**Catawba
Nuclear Station
(CNS)**

Duke Energy ERO Standardization

TSC/OSC ERO Position Comparison and Evaluation

Revision 0

Standard TSC Organization

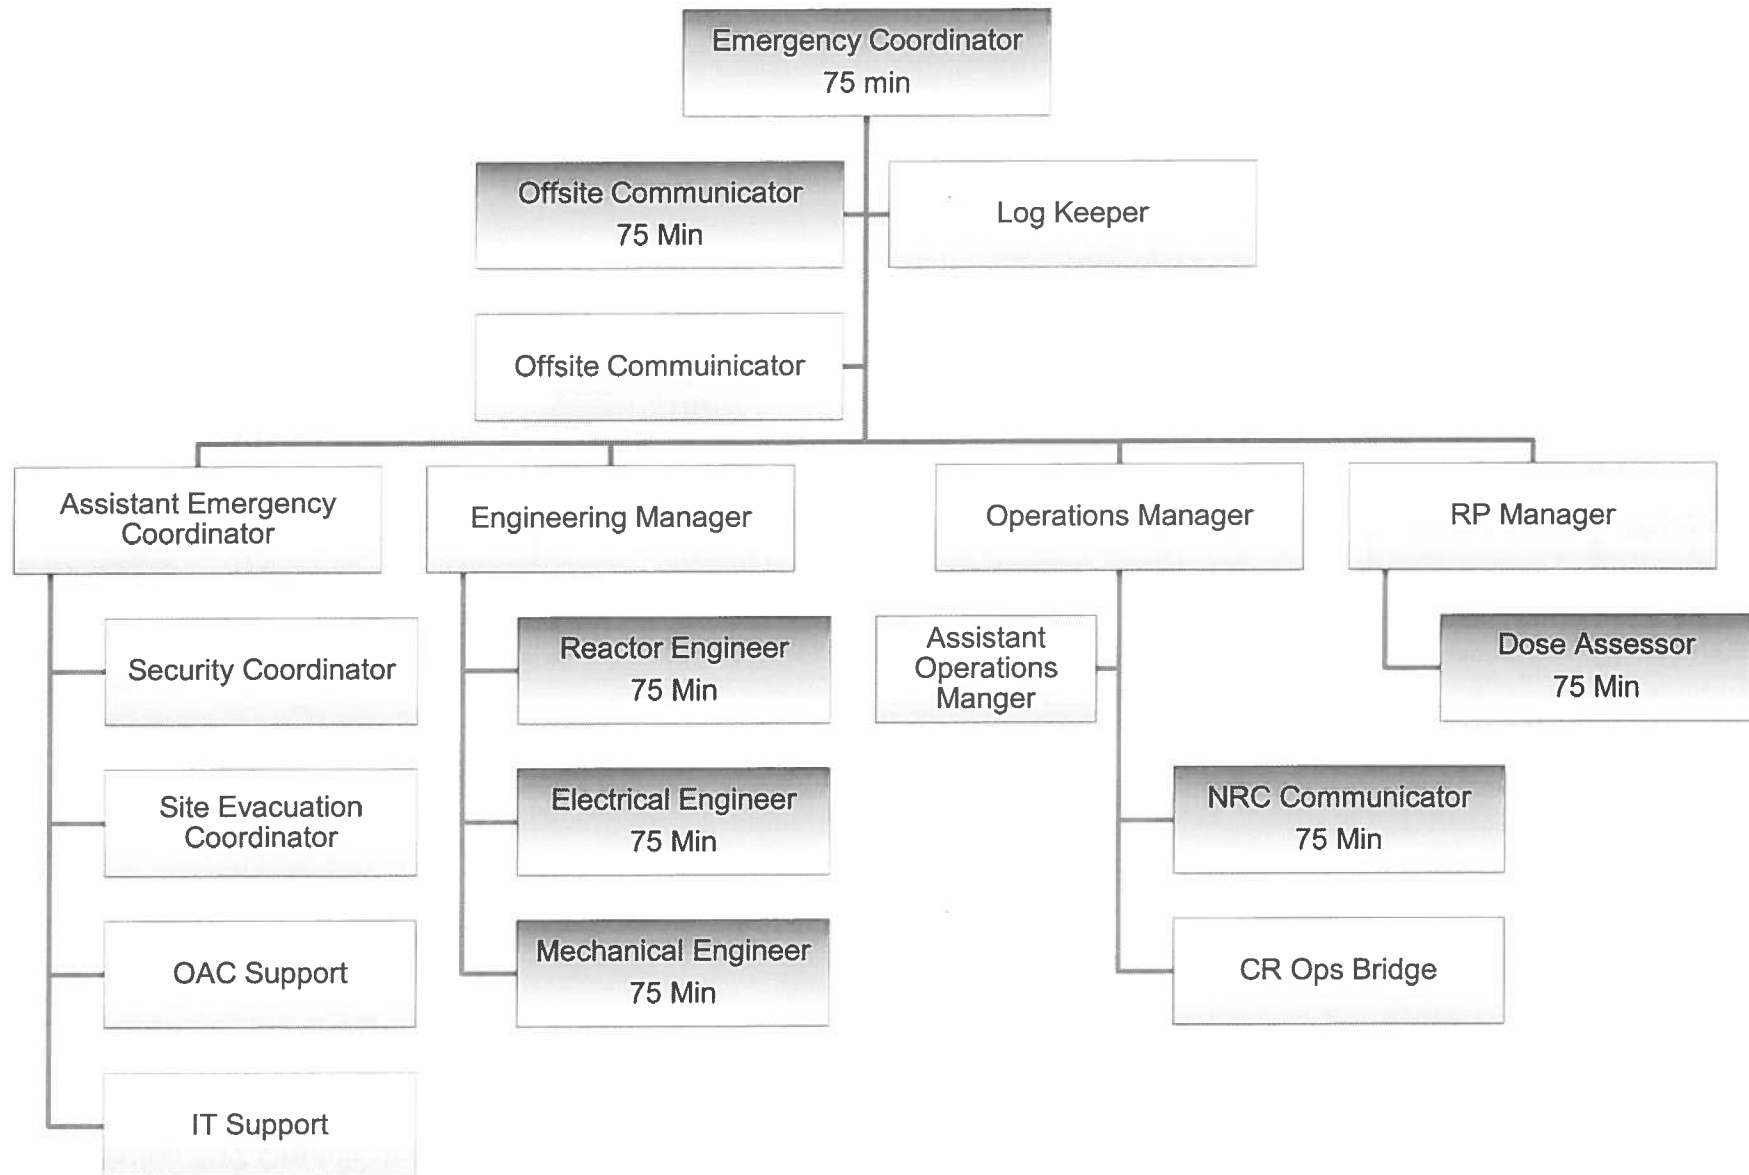
1.2.1. **TSC** – The TSC ERO staffing numbers remain at 19:

- 1) TSC IT Support was added (+1)
- 2) Electrical Engineer (moved from OSC) (+1)
- 3) Emergency Planner was removed (-1)
- 4) Assistant Operations Engineer was removed (-1)

Standard OSC Organization

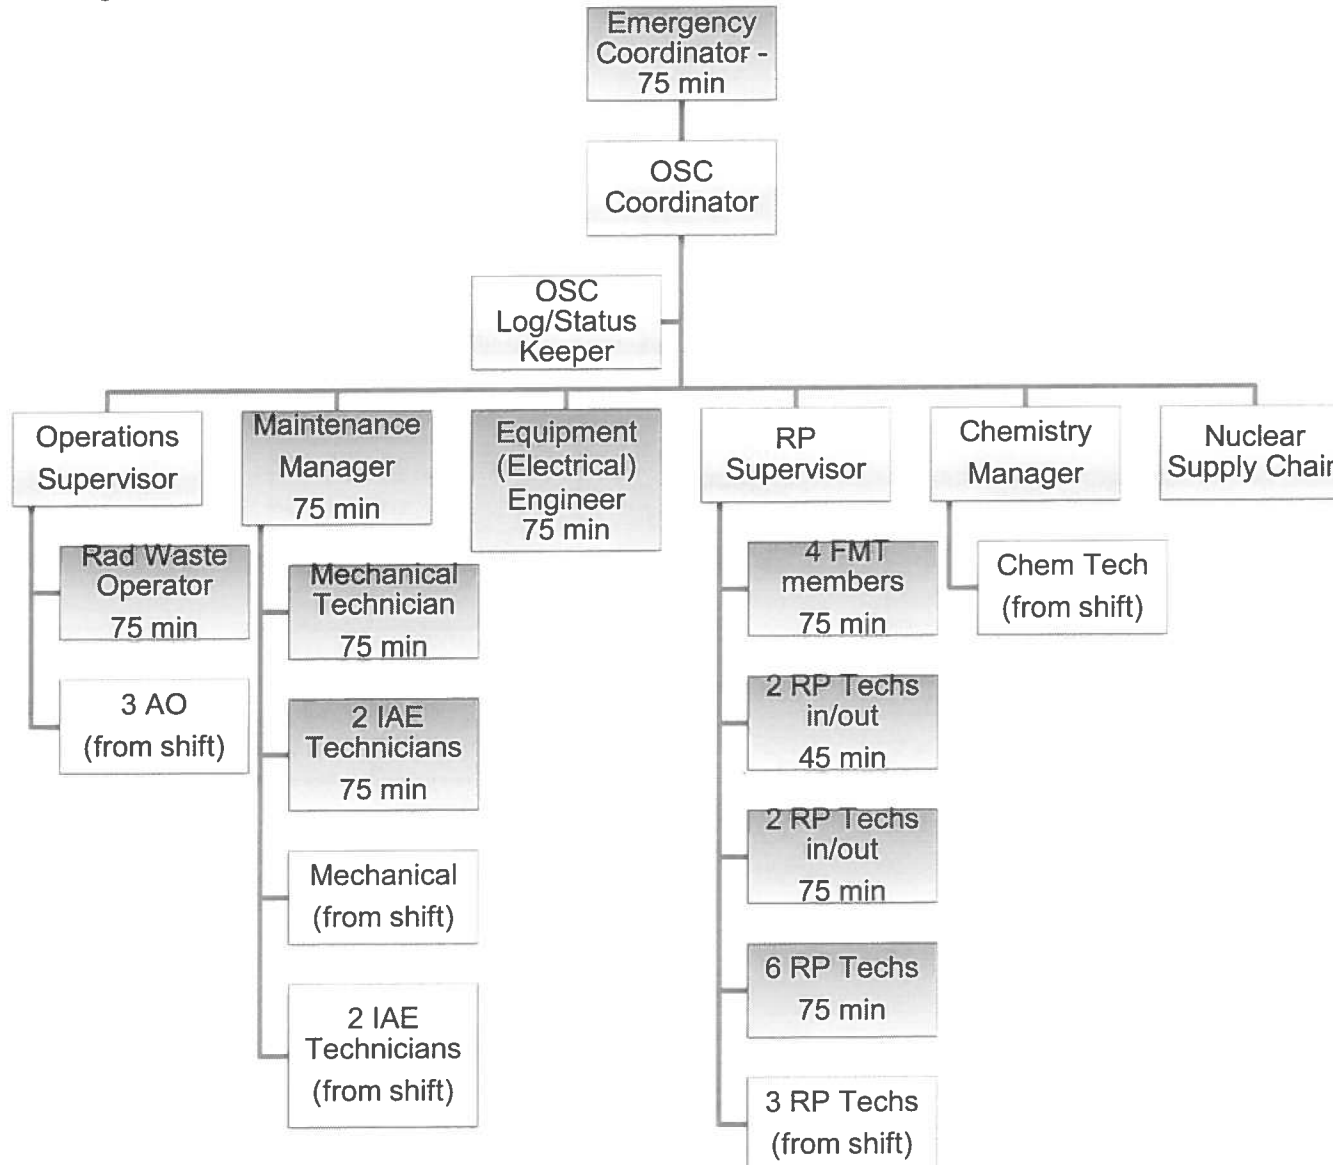
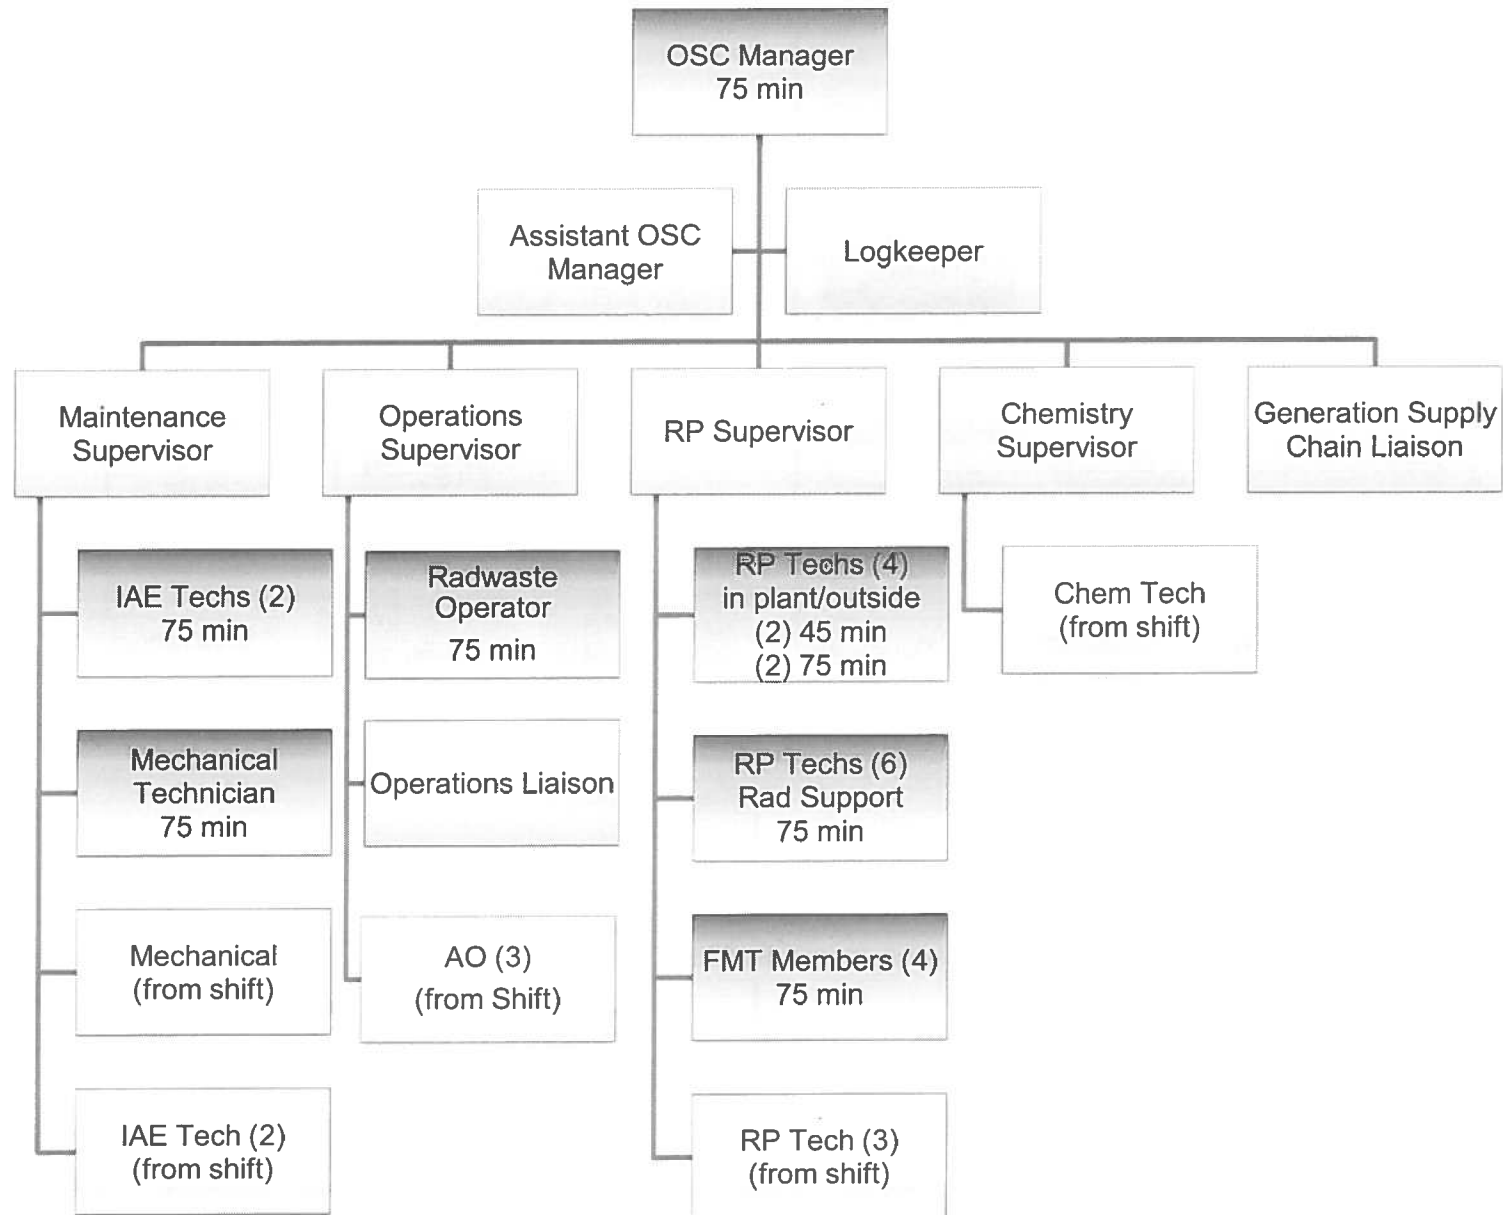
1.2.2. **OSC** – The OSC ERO staffing numbers remain at 27:

- 1) Assistant OSC Manager was added (+1)
- 2) OSC Operations Liaison was added (+1)
- 3) DRC Supervisor was removed (-1)
- 4) Equipment (Electrical) Engineer (moved to the TSC) (-1)

Standard Near-Site Media Center Organization

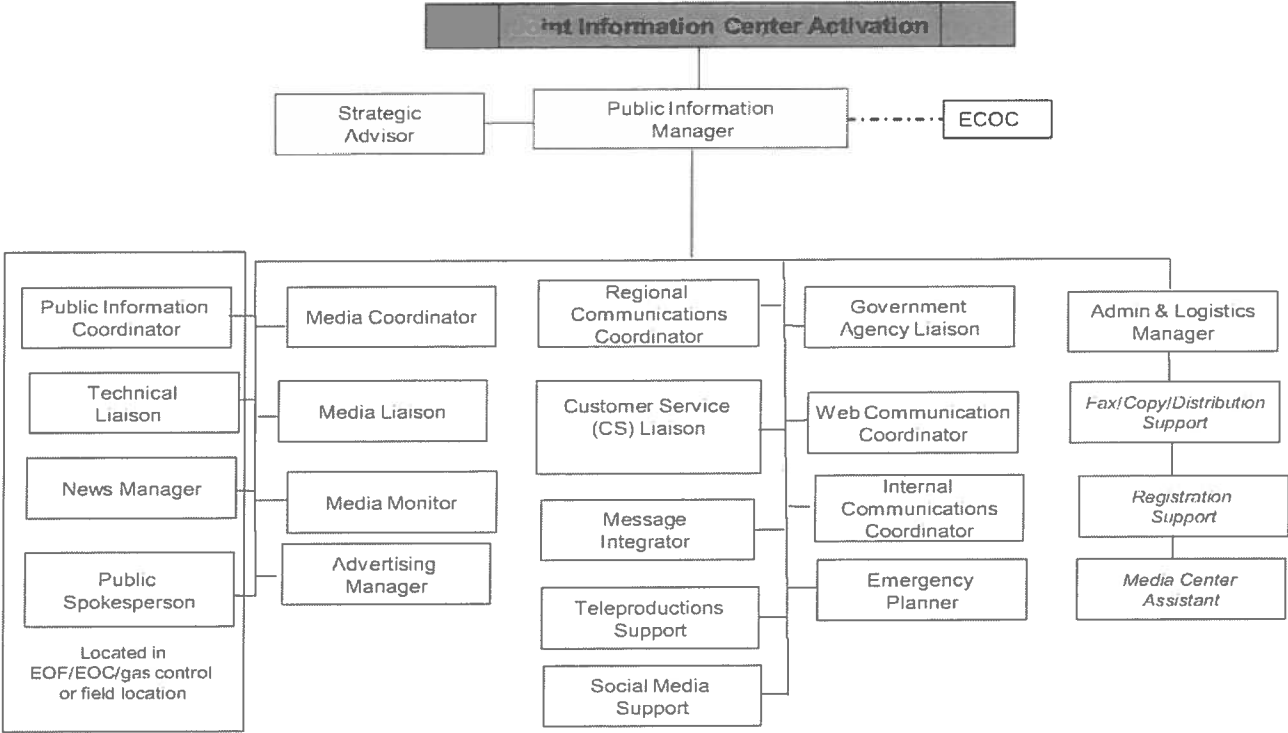
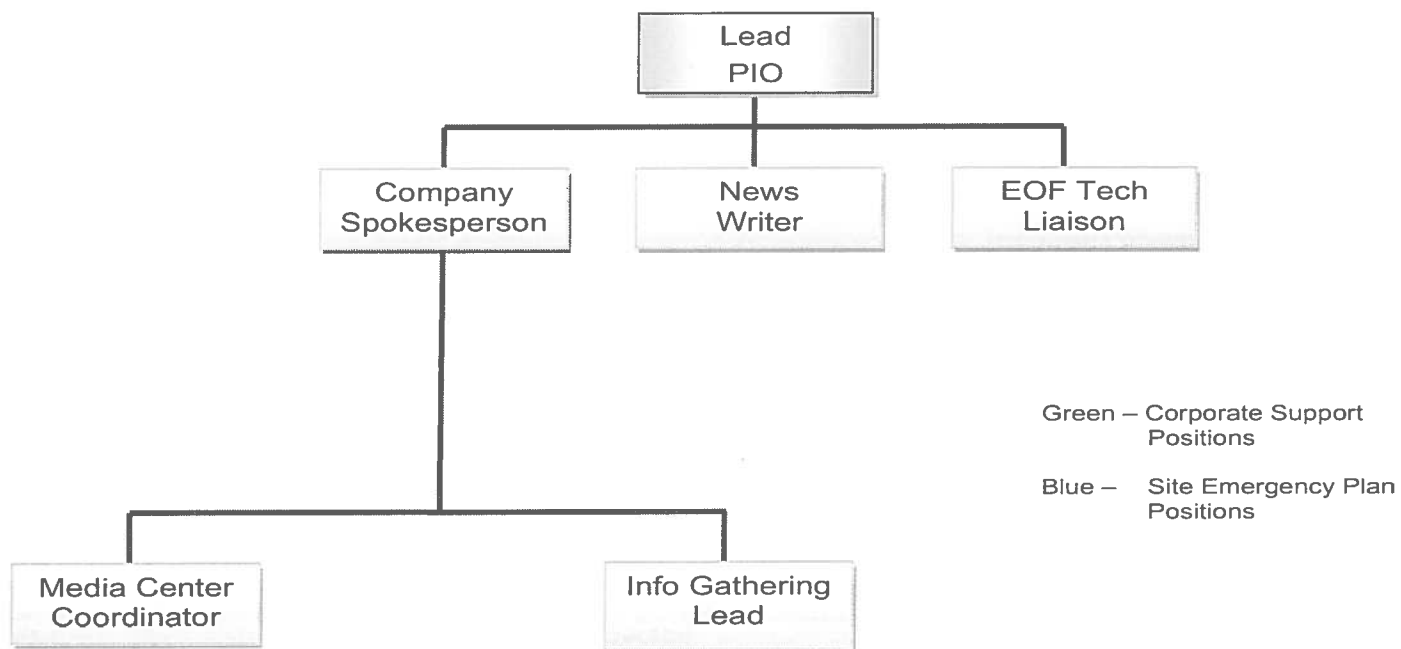
Old Title: Public Spokesperson (E-Plan G.4.a)
New Title: Company Spokesperson (E-Plan G.4.a; AD-EP-ALL-0108 Attachment 3)

Standard EOF Organization

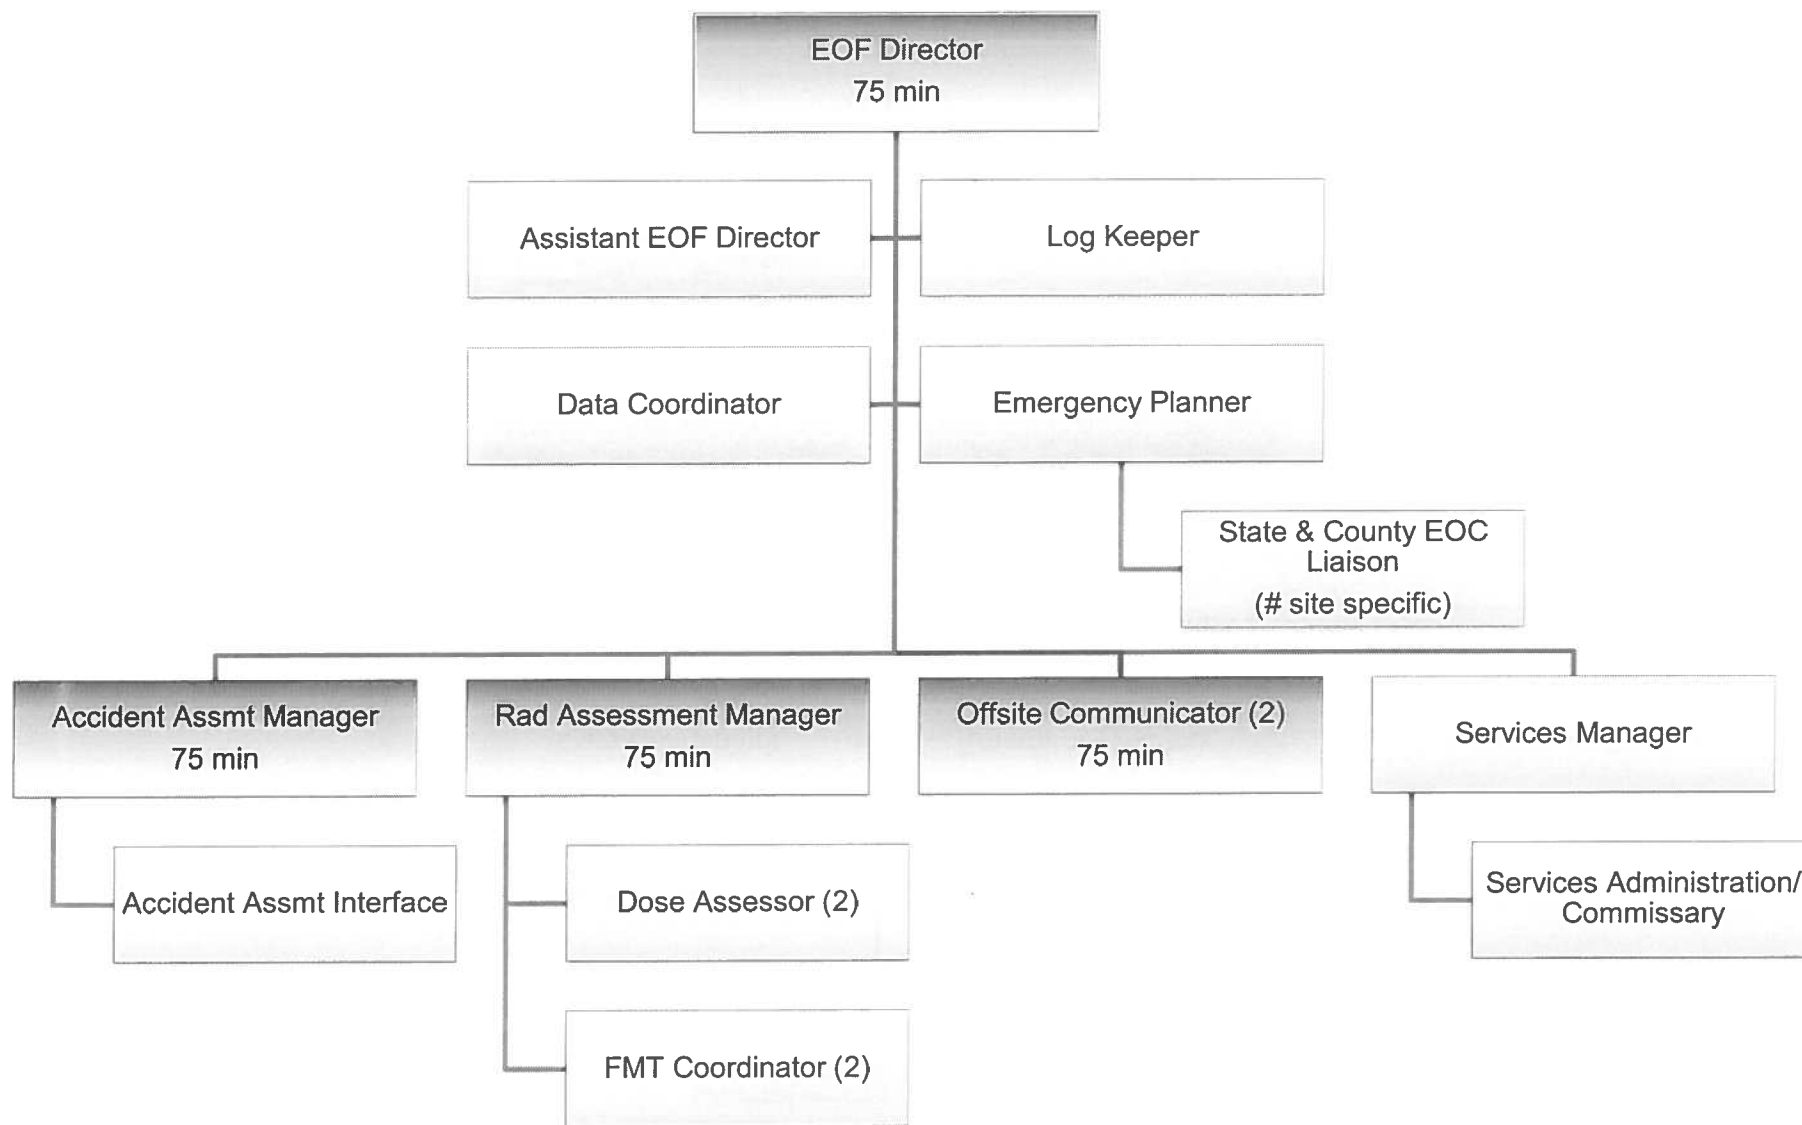
Old Title: EOF Director (SR/0/A/2000/003 R14 Enclosure 6.1)

New Title: EOF Director (AD-EP-ALL-0103 Attachment 1)
